## Stakeholder Comments Template

### Resource Adequacy Enhancements – Straw Proposal Part 1

Submitted by	Organization	Date Submitted
<i>Nuo Tang</i> <a href="mailto:ntang@semprautilities.com">ntang@semprautilities.com</a>	<i>San Diego Gas &amp; Electric</i>	<i>2/6/2019</i>

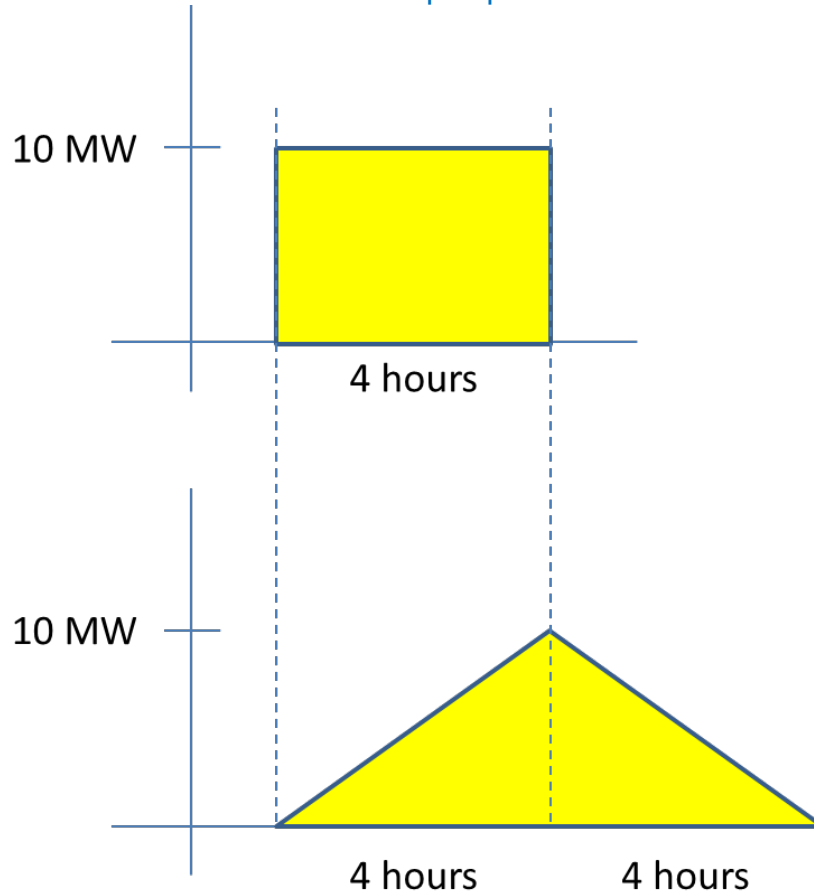
- i. Please provide your organization's feedback on the Availability & Performance Assessment Triggers options presented in the proposal.

Please see SDG&E's comments above.
